ADDENDUM No. 1

RFP No. 22-21

2022 Sidewalk Gap Elimination Project

SCALE PLAN: 1" = 10'
DRAWING No. 2022007-6

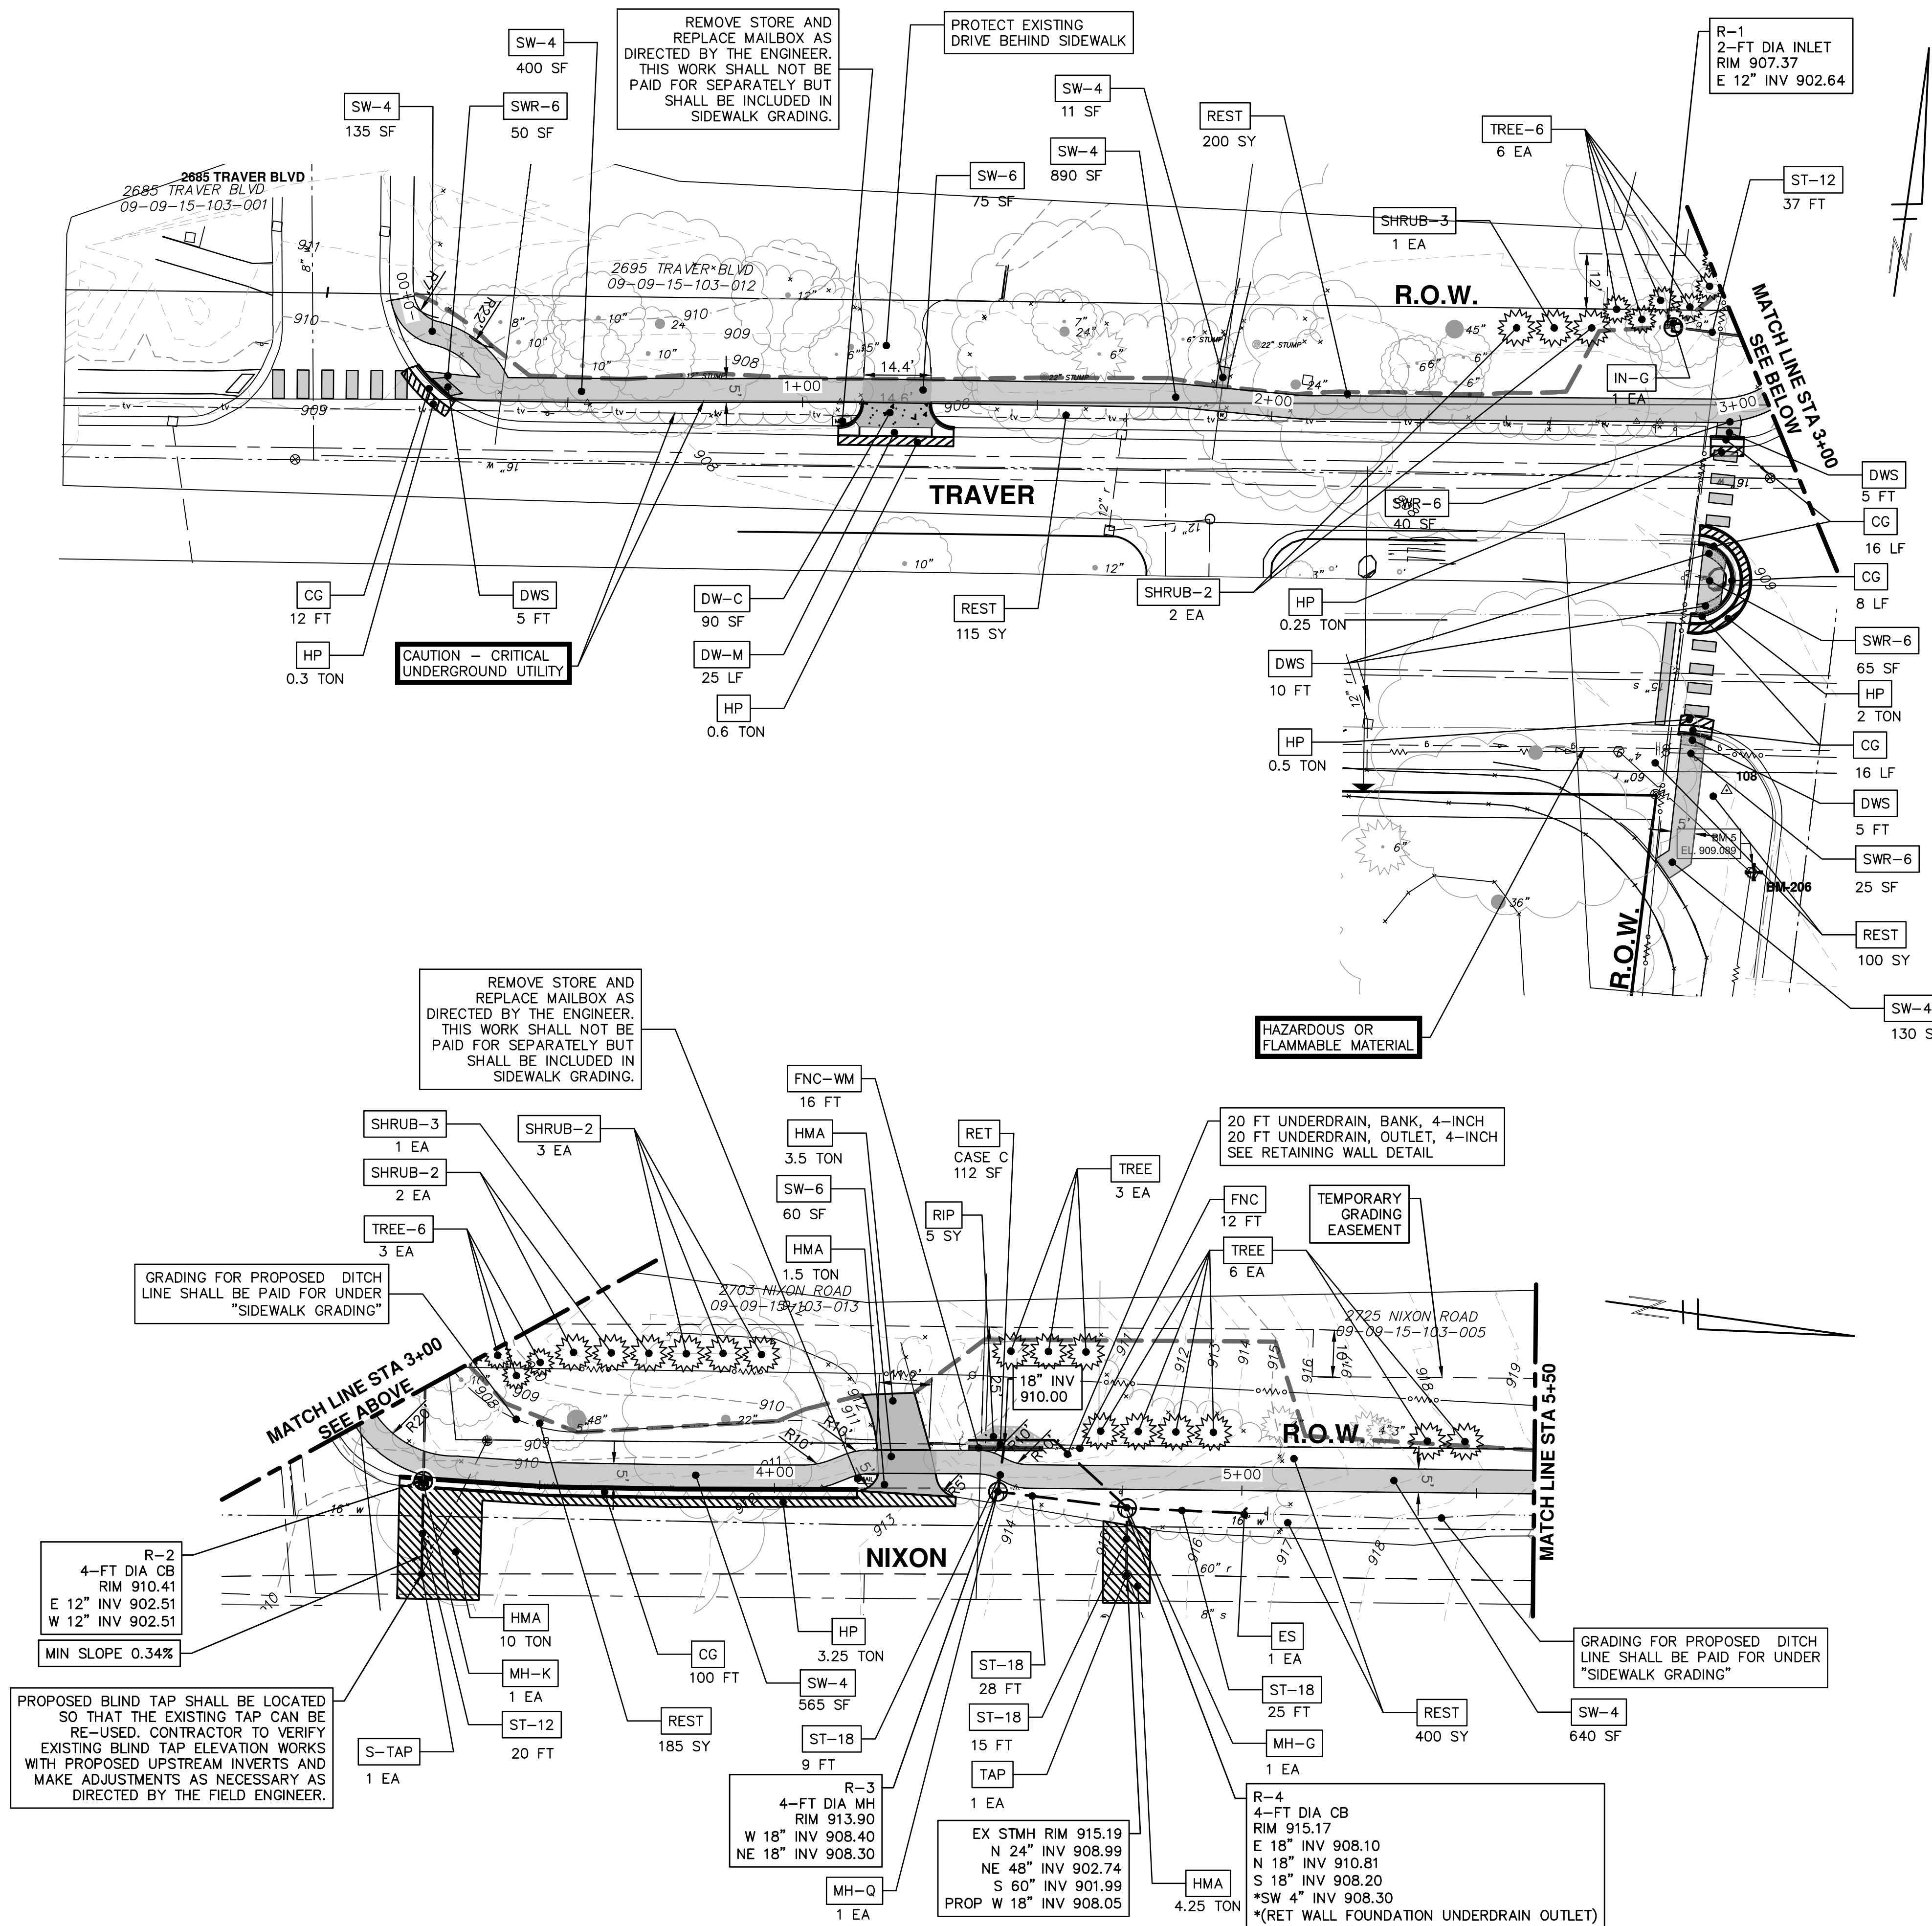
Section/Page(s)	Change
Detailed Specification / Page DS-36	Additional information added to Measurement and Payment.
Drawing Plan / 6 of 24	Revised alignment of sidewalk.
Drawing Plan / 16 of 24	Revised callout on mailbox at Sta. 5+82 (2725 Nixon)
Drawing Plans / 15, 16, 18, 19, 22, 24 of 24	Added Stationing for clarity of plans.
